94 BANK ST

Landmarks Preservation Commission Public Hearing

Summary of comments and changes

PROPOSED NORTH ELEVATION
SCALE=1/8"=1'-0"

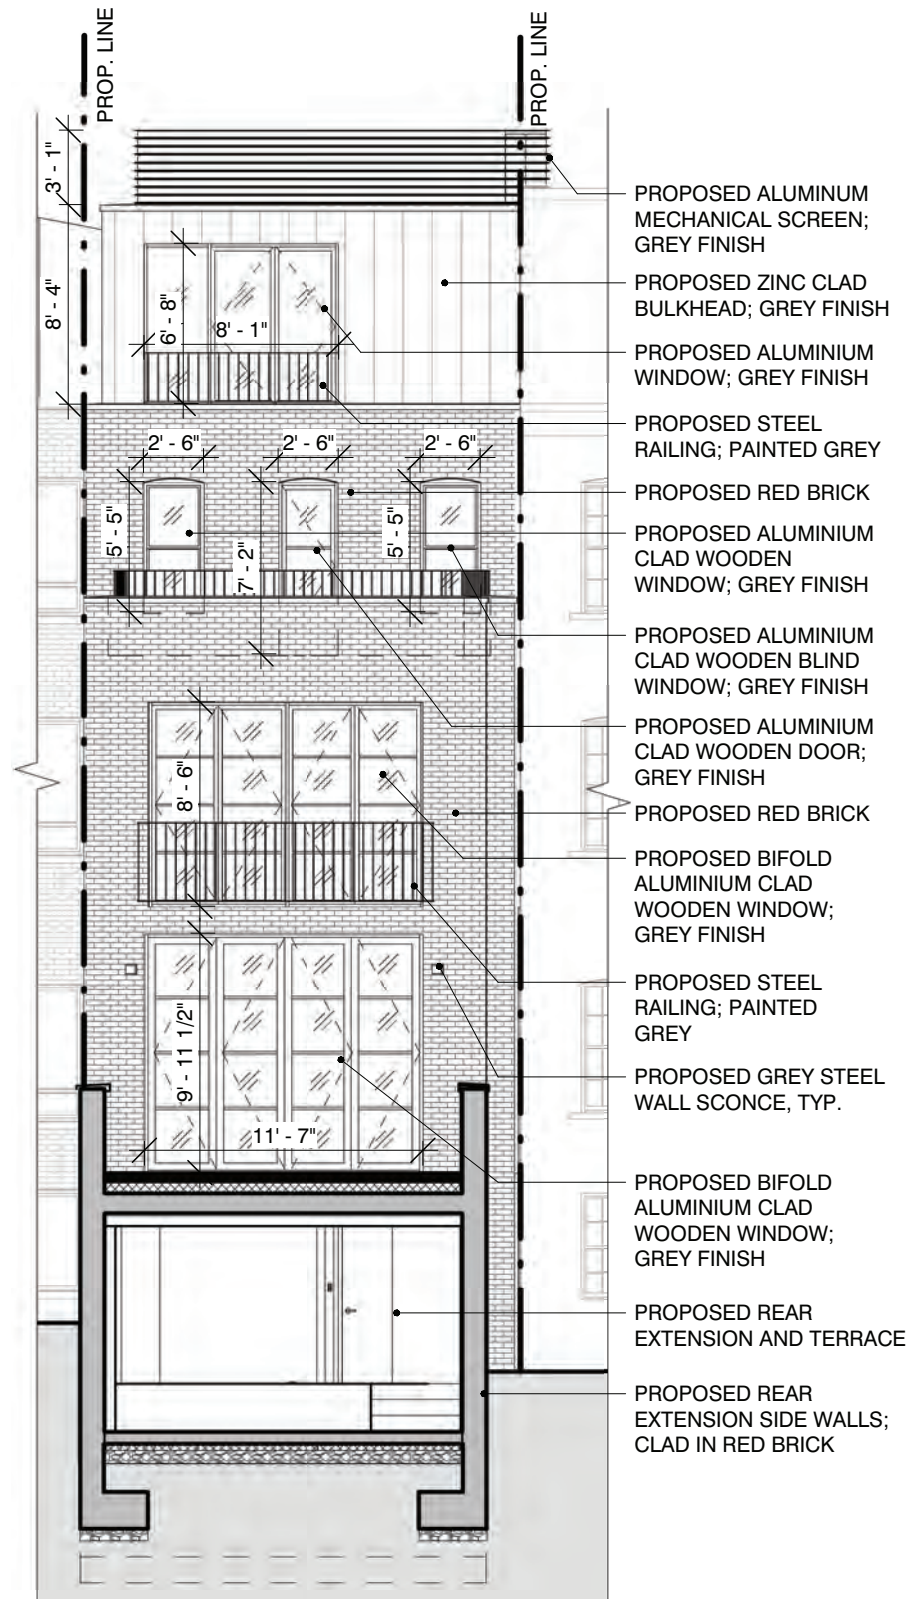
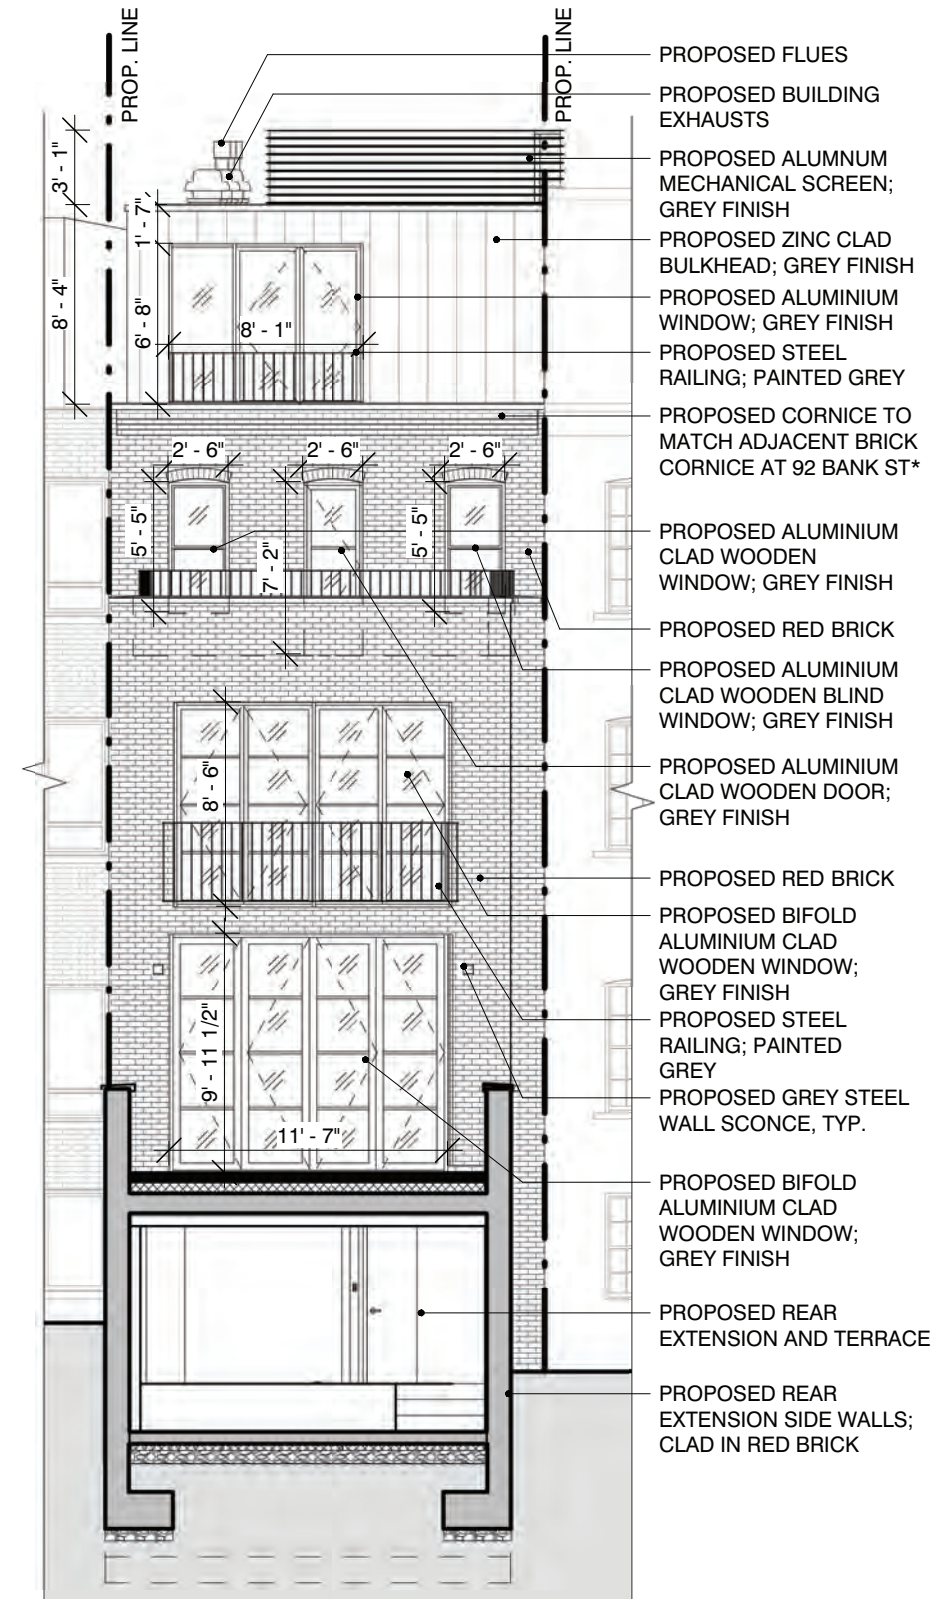
- Commissioners' comments: The angles of the rooftop and rear-yard additions do not respect the house's angles and create a discordant appearance.

- Commissioners' comments: Rear elevation features should be reconstructed.

Response: The angles of the rooftop and rear-yard additions have been rationalized to be in alignment with the house.

Response: The missing brick cornice is proposed to be reconstructed based on 92 Bank Street's. The top floor window lintels will be retained.

MOCK-UP AT ROOF
(2025/07/22)

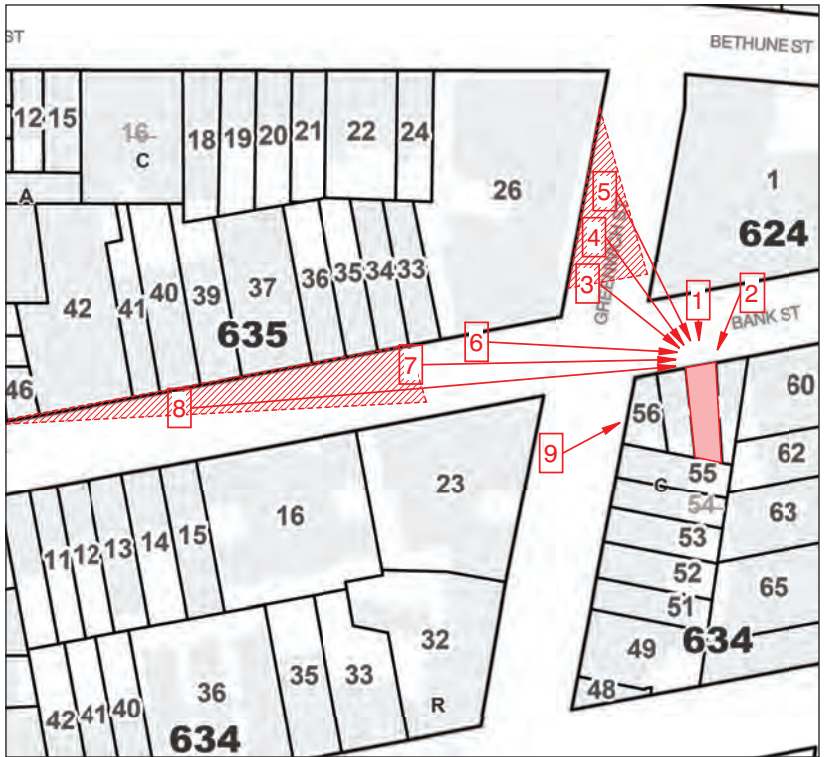
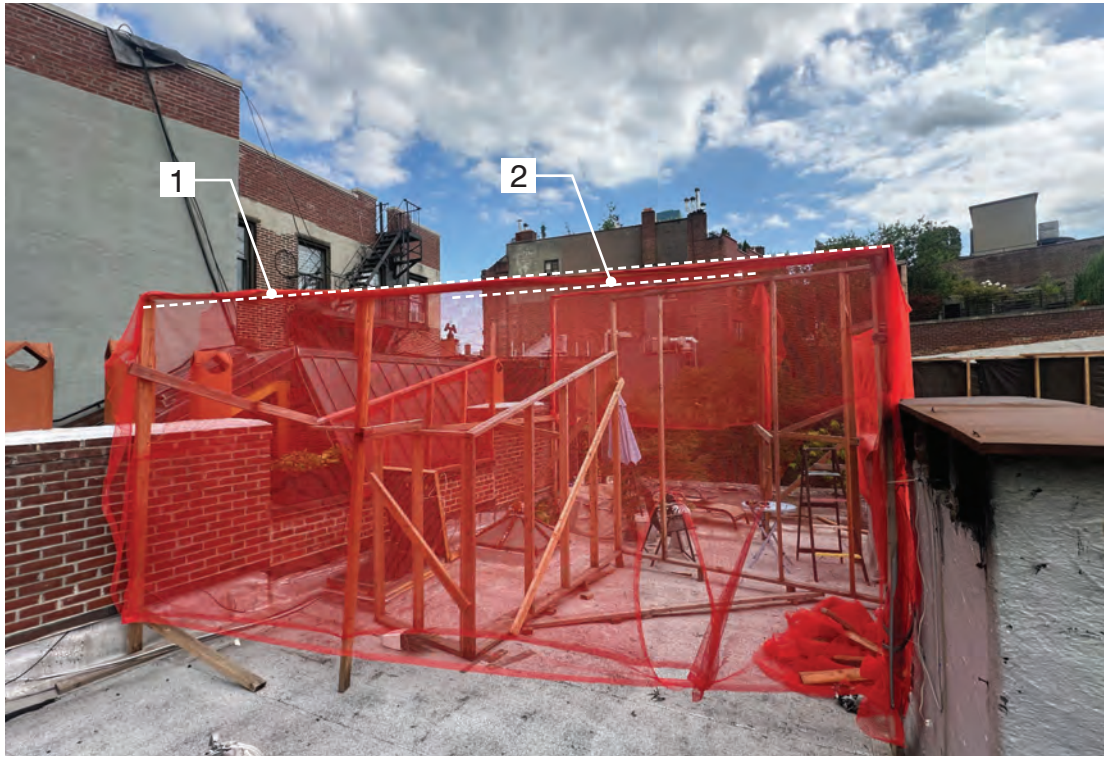
- Commissioners' comments: The visibility of the mechanicals should be decreased.

Response: The footprint of the mechanical enclosure has been decreased so that it is no longer visible from Greenwich St and Bank St.
